**CITY OF KIRKLAND**  
**Planning and Community Development Department**  
 123 Fifth Avenue, Kirkland, WA 98033  
 425.587-3225 - www.kirklandwagov

**ADVISORY REPORT**  
**FINDINGS, CONCLUSIONS, AND RECOMMENDATIONS**

**File:** **ZON12-00006 NORTHSTAR MIDDLE SCHOOL RELOCATION TO BEST HIGH SCHOOL CAMPUS**

DEMOLITION  
SITE PLAN

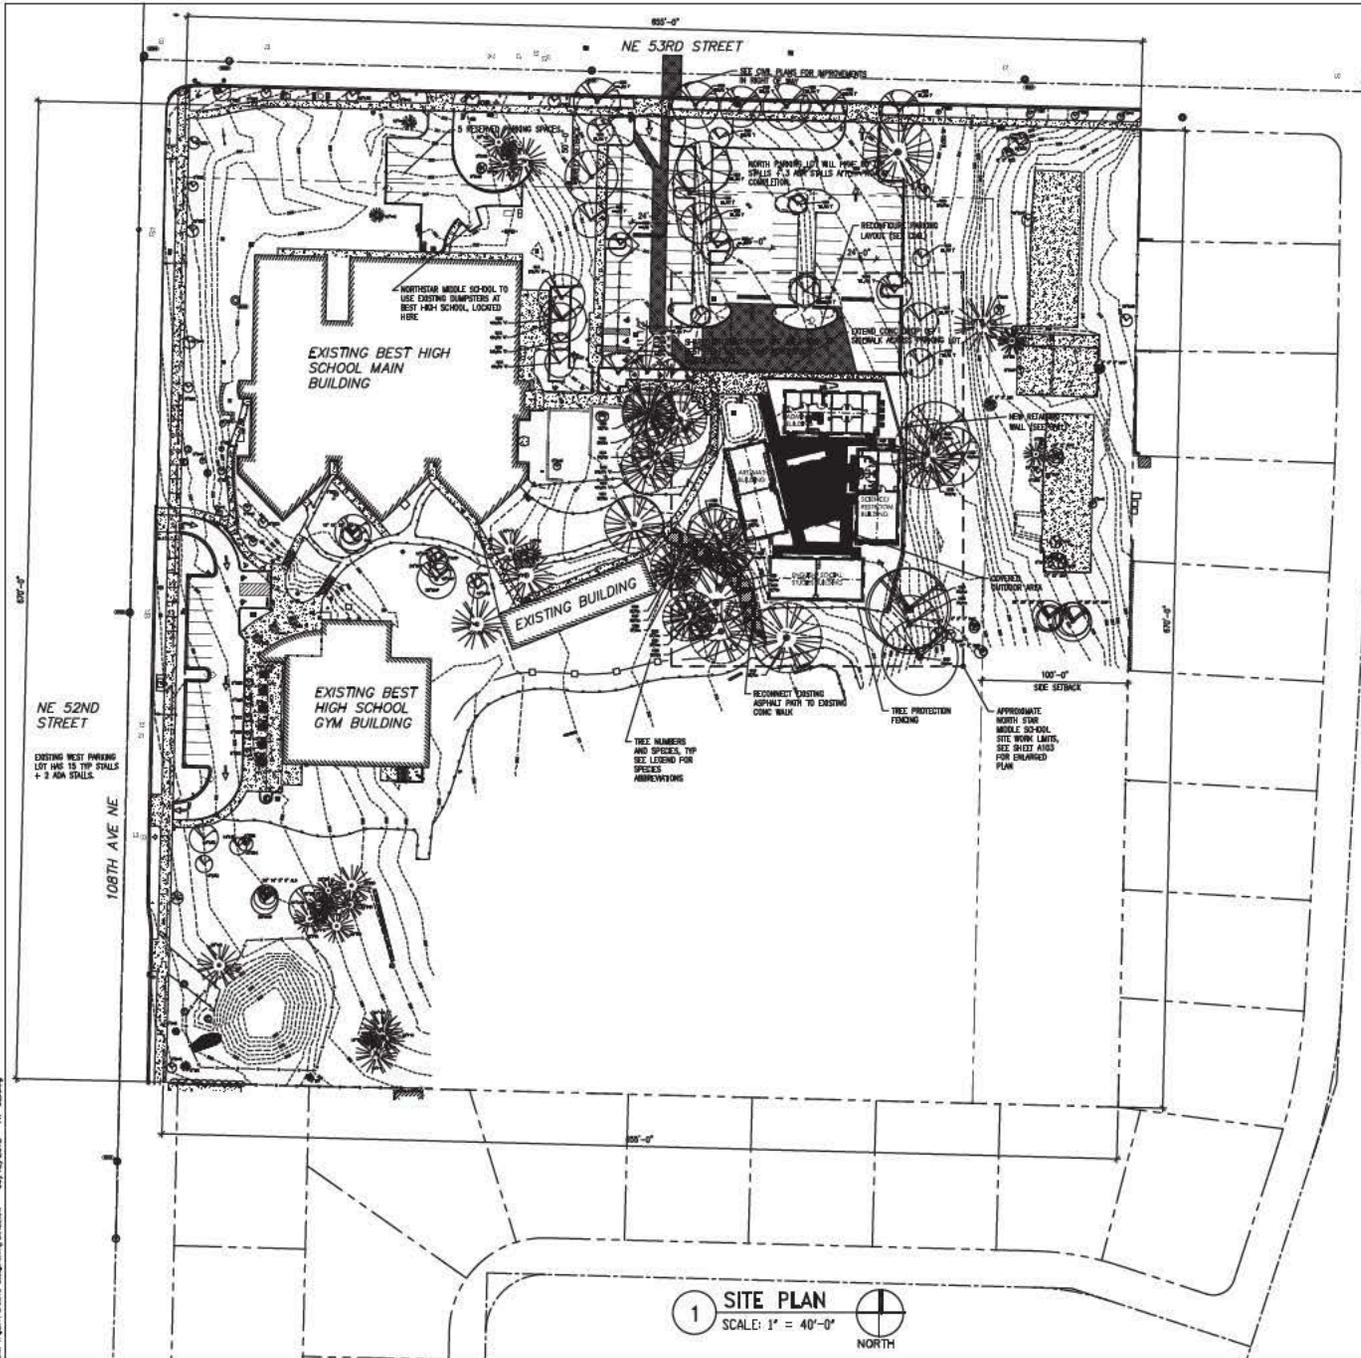
- (1) The applicant shall correct the tree protection fencing near the north parking lot trees, to allow for access to the site and indicate the fence openings at the northwest and northeast corners.

- (2) Include arborist instructions for trees impacted west and south of the new portables on the site plan. These instructions are included on pages 23-24 of the arborist's report. Add tree numbers 1655, 1656, and 1657 to the list of trees to be protected. (see Conclusion II.G.7).
